**Share Food Program  
Delaware County Warehouse Renovation  
General Construction - Request for Proposals  
Addendum #2**

**ADDENDUM NO. 2**

**DATE:** November 21, 2022

**RE:** Share Food Program - Delaware County Warehouse Renovation

1 FLOOR PLAN  
SCALE: 1/8" = 1'-0"

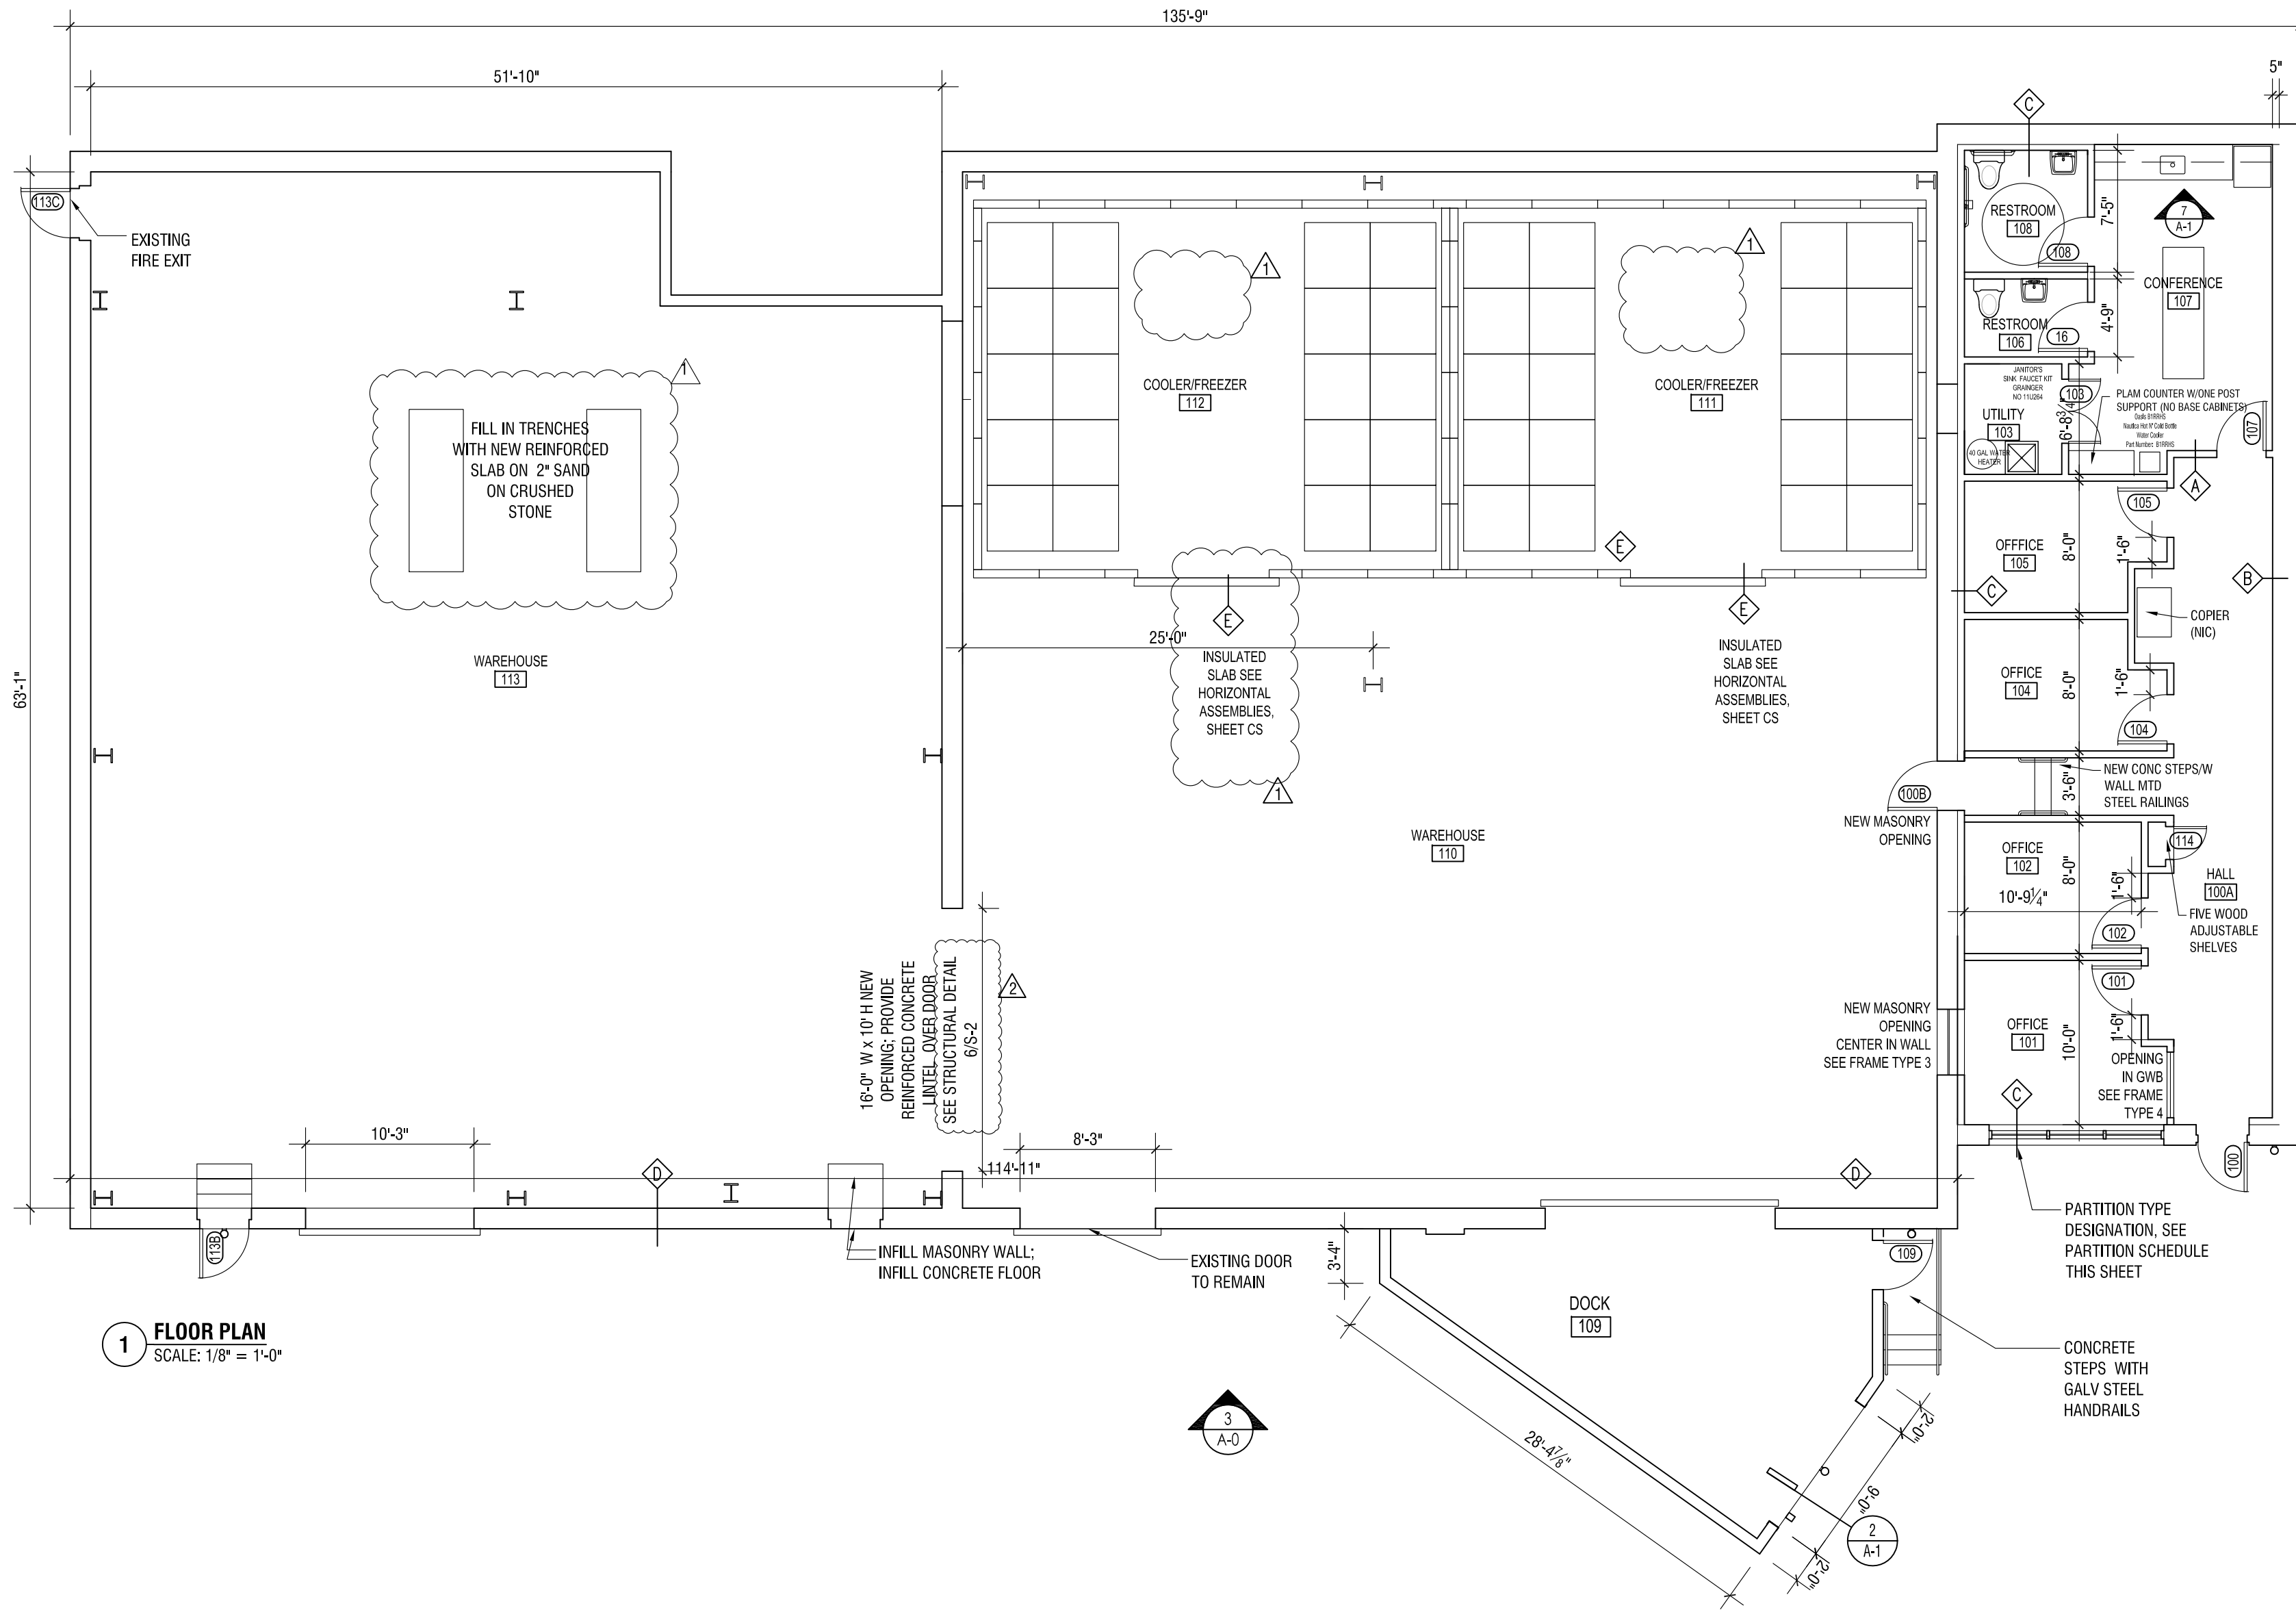
Remove and replace drawing A-1 Dated 11/15/2021 and replace it with drawing A-1 Dated 11/21/2022. Changed specification for water cooler, added reference to lintel detail on drawing 1, revised specification for refrigerator, detail 8, revised specification for Epoxy floor, finish schedule.

Answer: Set issued with A-2 included.
8. Question: Please provide wall infill detail west of freezer 112. No details provided but it does appear to have the existing opening infilled.

Answer: Infill wall with 6" CMU installed flush with warehouse side.
9. Question: Please indicate where Removal Note 16 on D-1 applies on the plans  
Answer: Duplicate note removed from Drawing 1/D-1. We changed note 16 to clarify that the removal scope includes a concrete slab PLUS wood floor and floor joists over framed in those rooms.

## LINTEL BEARING DETAIL

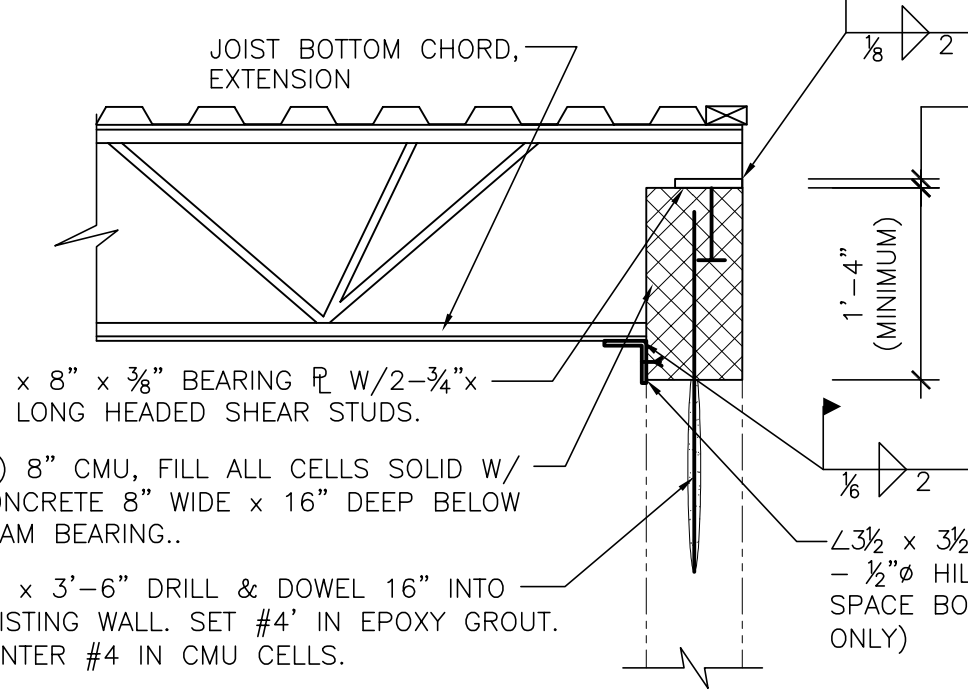
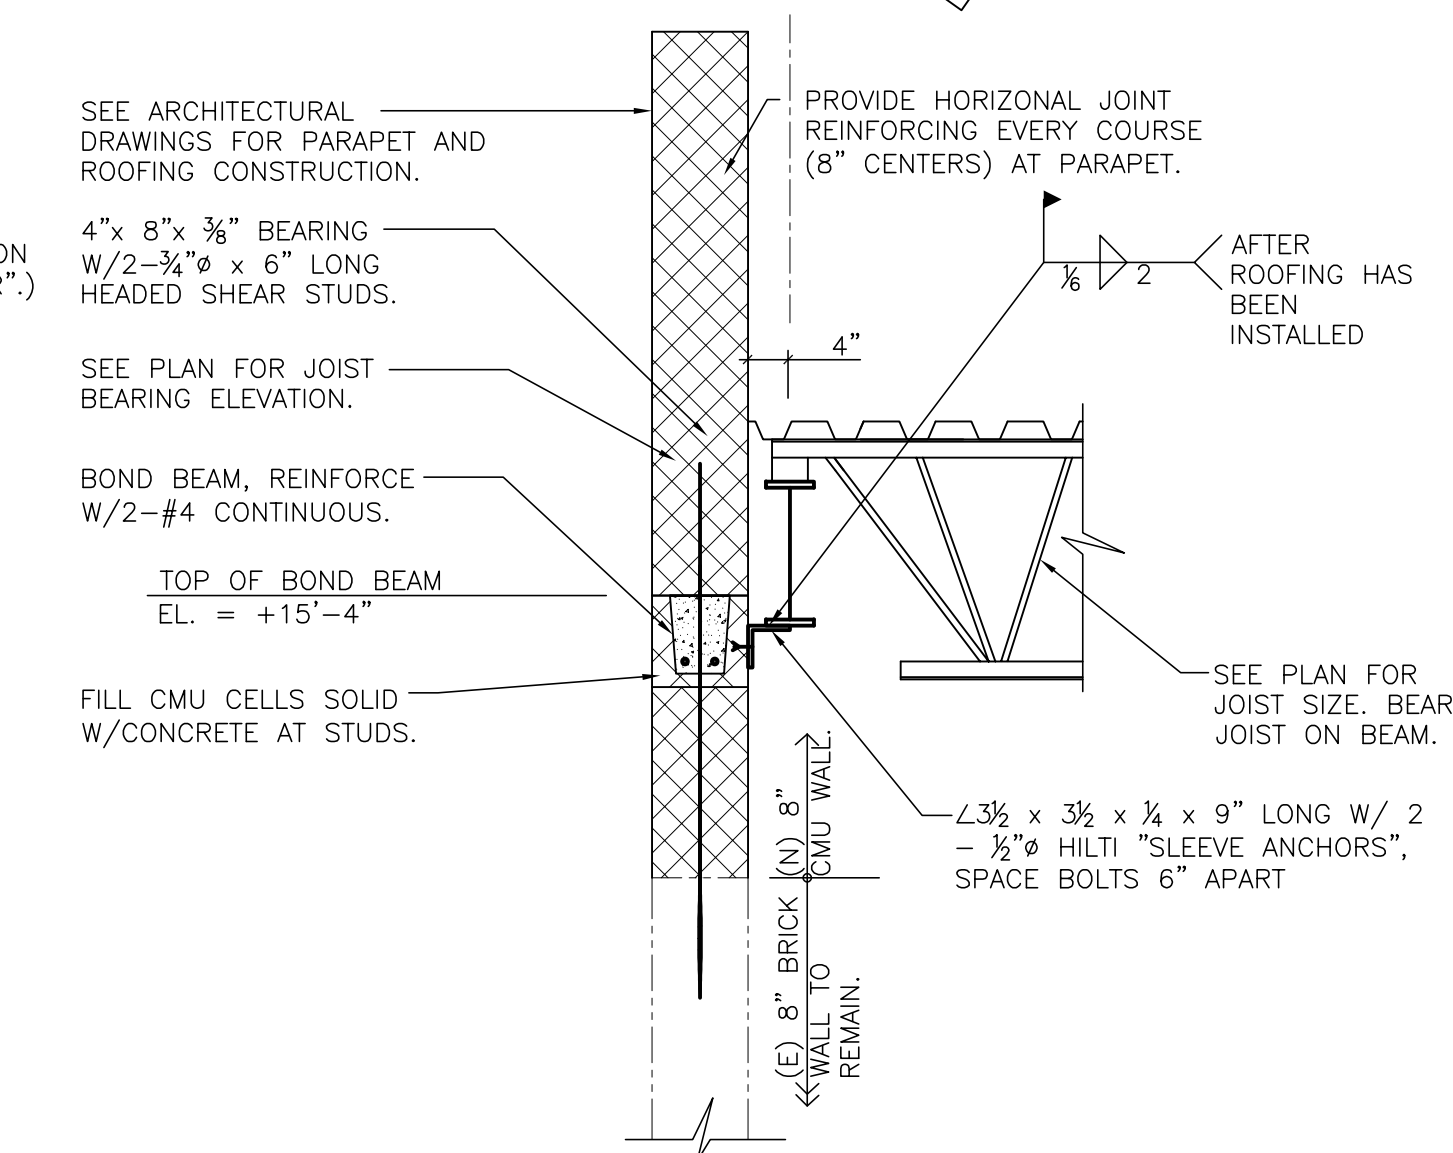
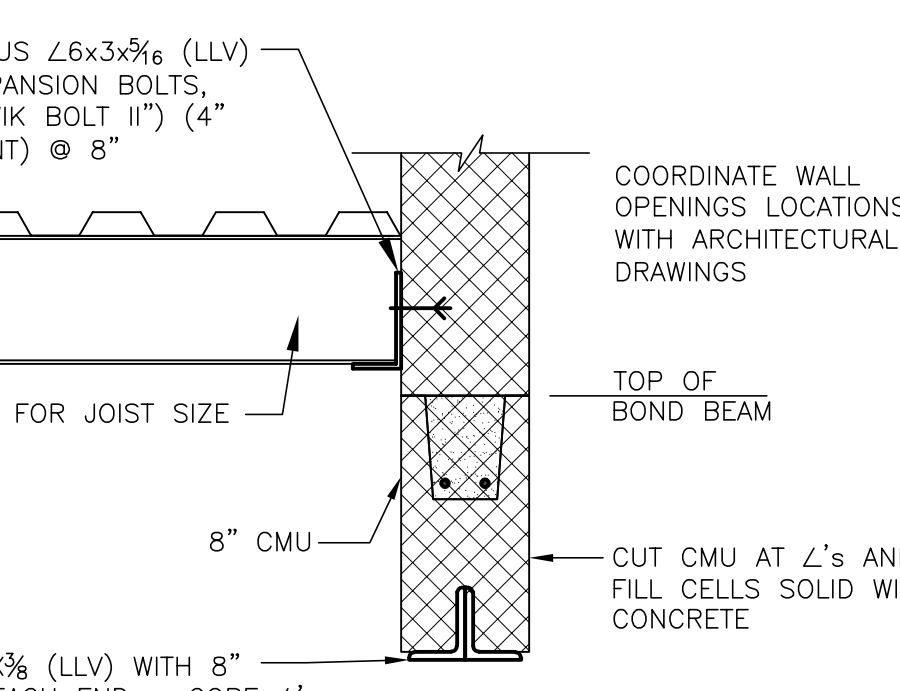
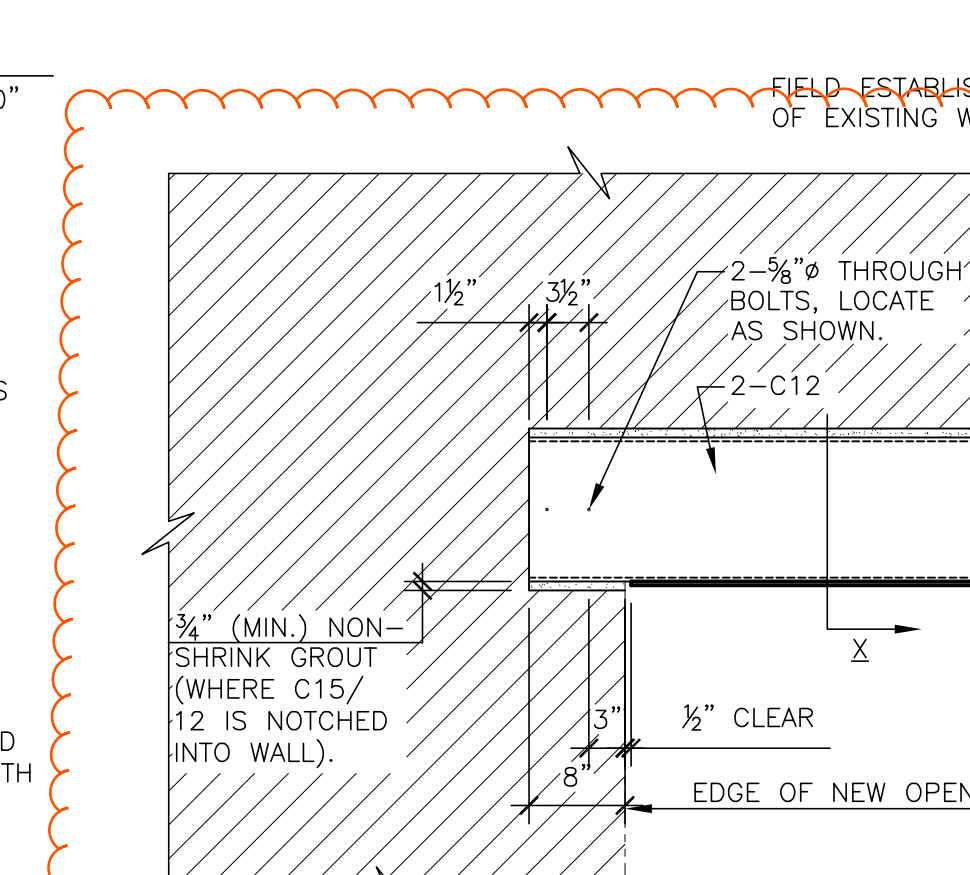
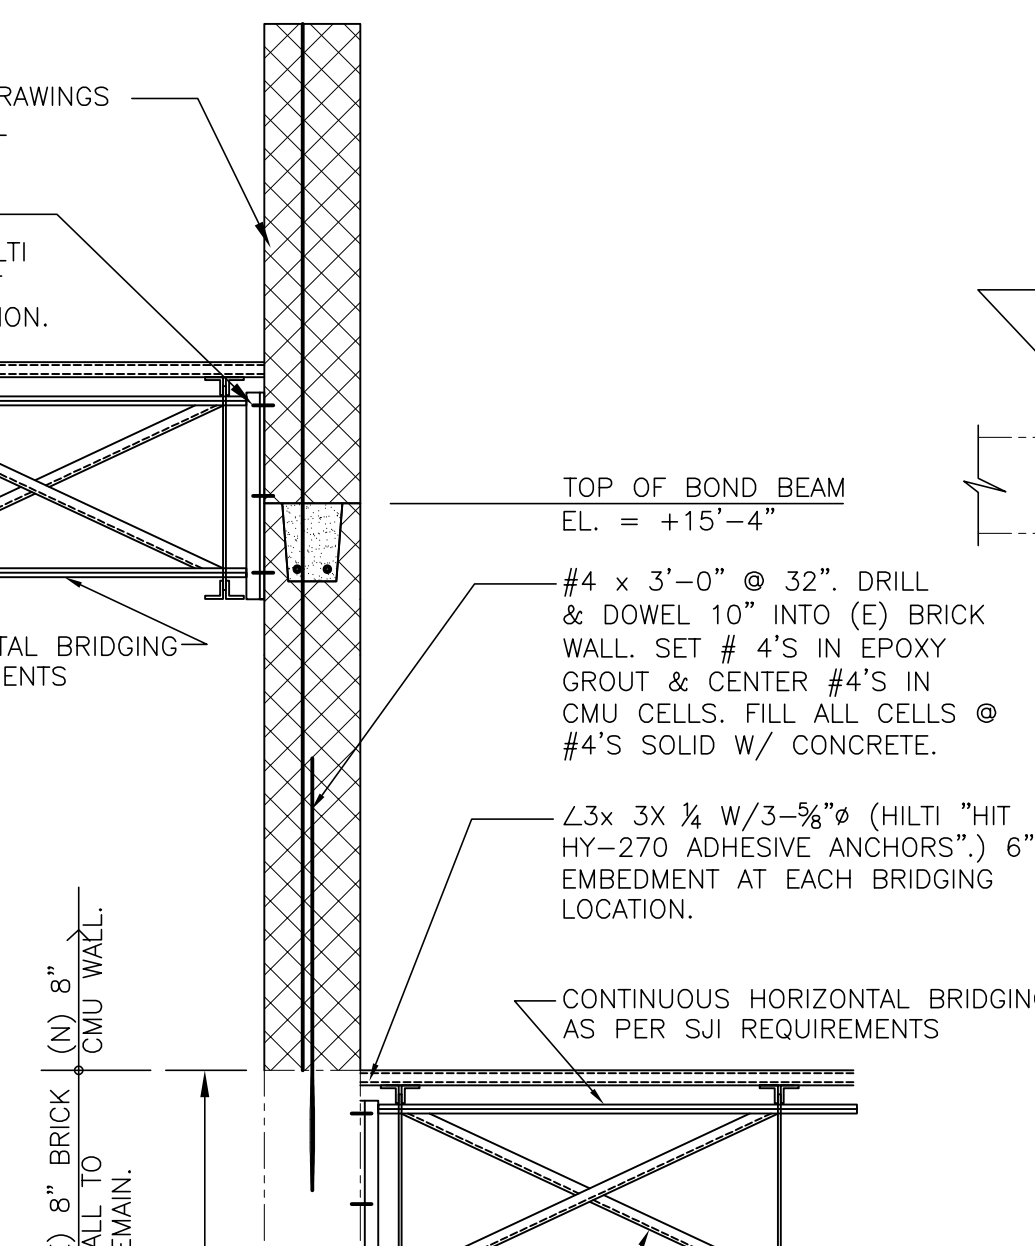
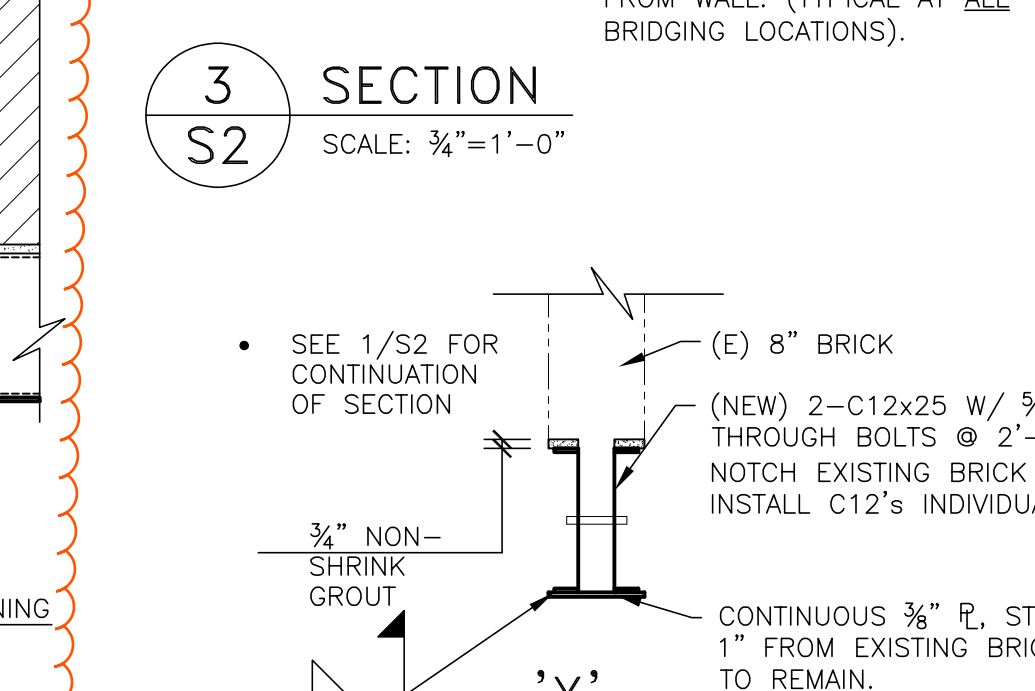
Remove and replace S-2 Dated 11/8/2022 and insert Sheets S-1 & S-2 Dated 11/21/2022. Added lintel details at large interior masonry opening and at windows from offices into warehouse.
